# DEVELOPMENT REVIEW COMMITTEE (DRC) COMMENT REPORT

**PROJECT NAME:** The Jim Moran Foundation

**CASE NUMBER:** UDP-S22046

**REQUEST:** Site Plan Level III Review: Parking Reduction Request  
for 63,151 Square-Foot of Office Use

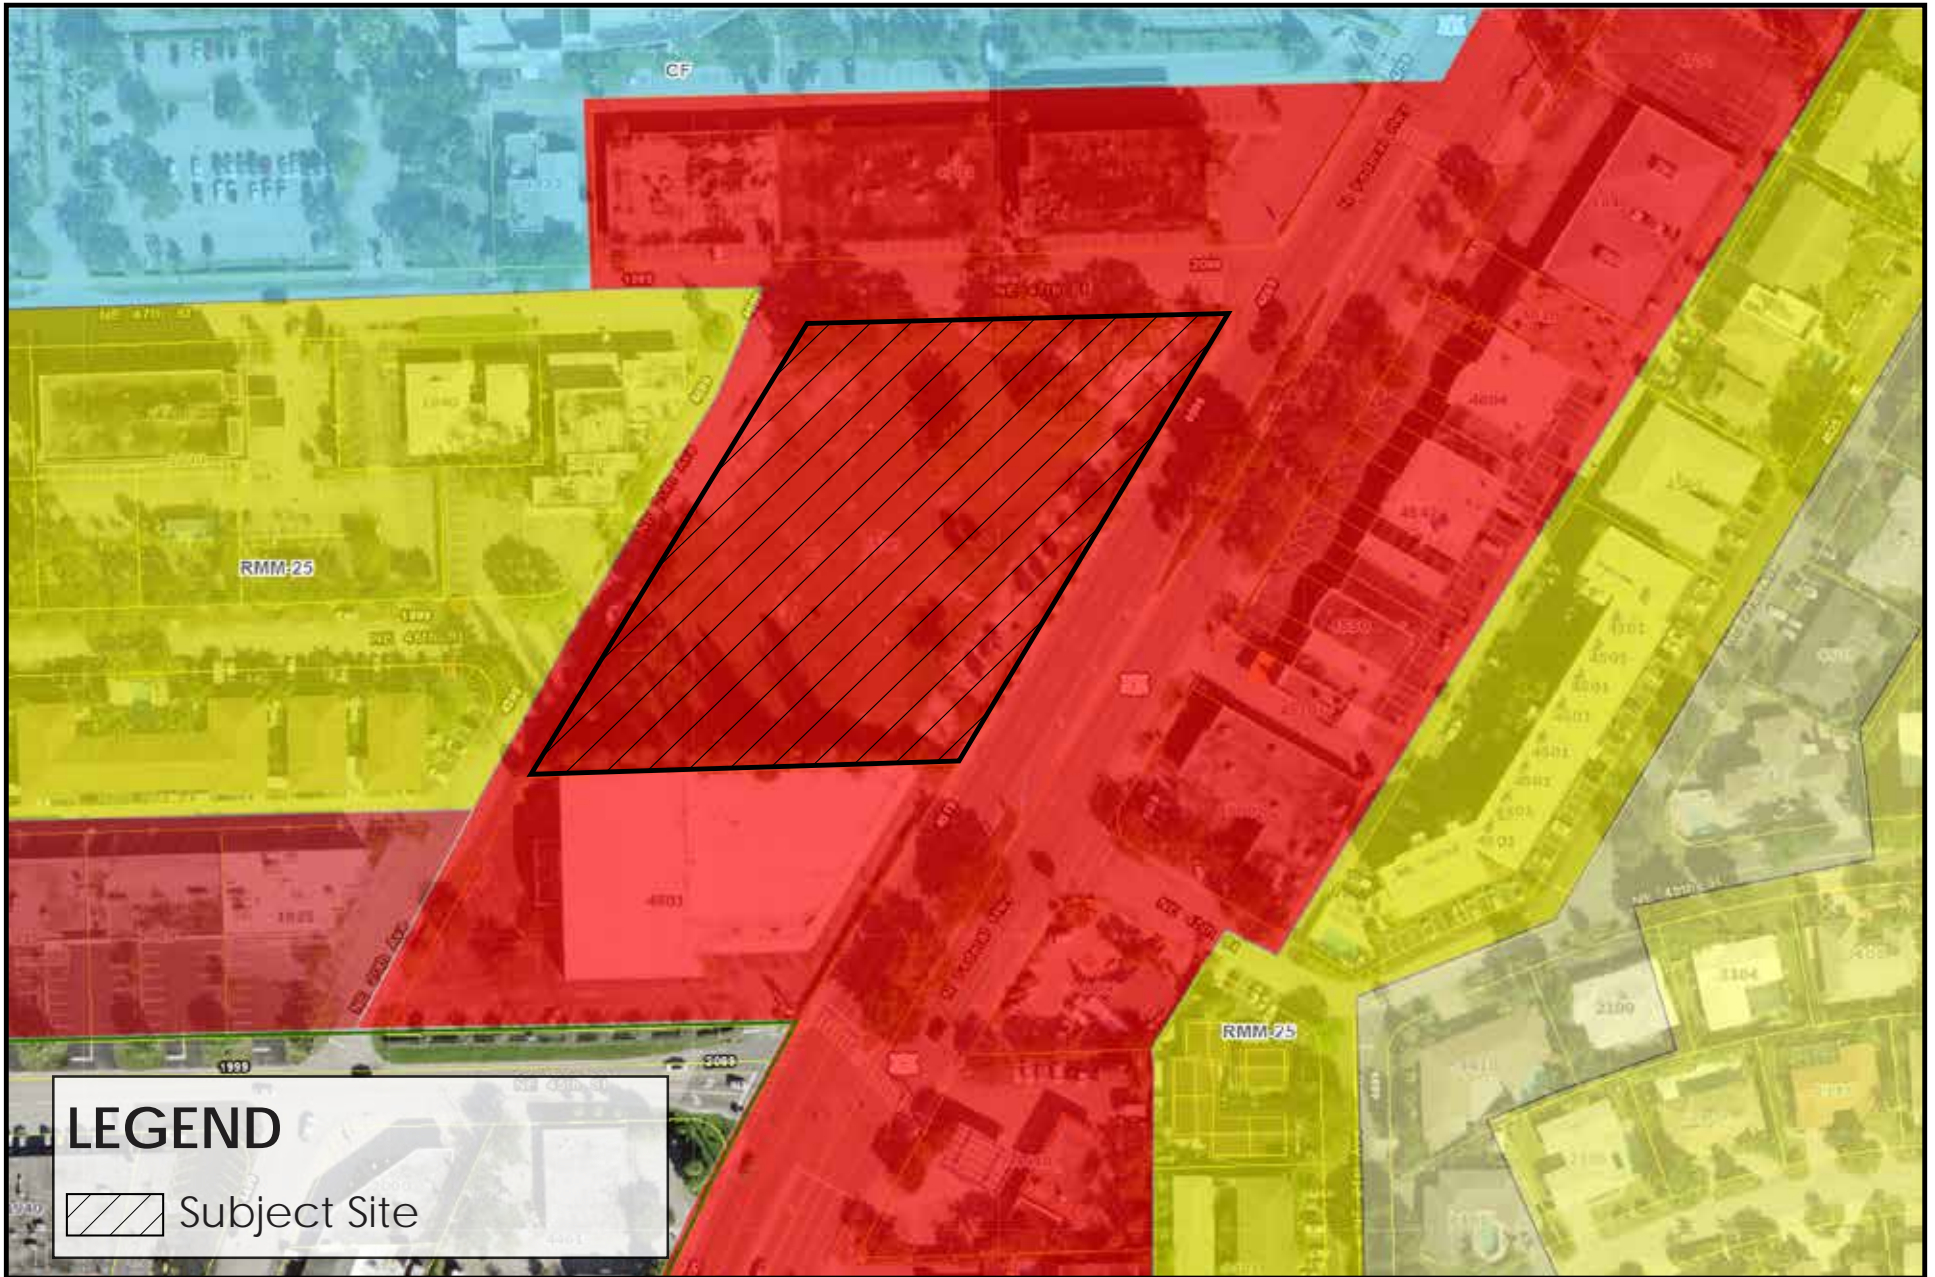
- a. Provide exact model of Jacob Rail fencing chosen for the site. Consider using a more elegant, transparent design solution in lieu of the proposed of Jakob Rail fencing to enhance the architectural of the building, the public realm and pedestrian experience along N. Federal Highway/US 1. fencing in Alternatives may include garden terracing or a 3-4 foot high decorative stone wall matching the building's material, with columns to break up monotony, topped off with picketed wrought iron fencing, etc. Examples below:
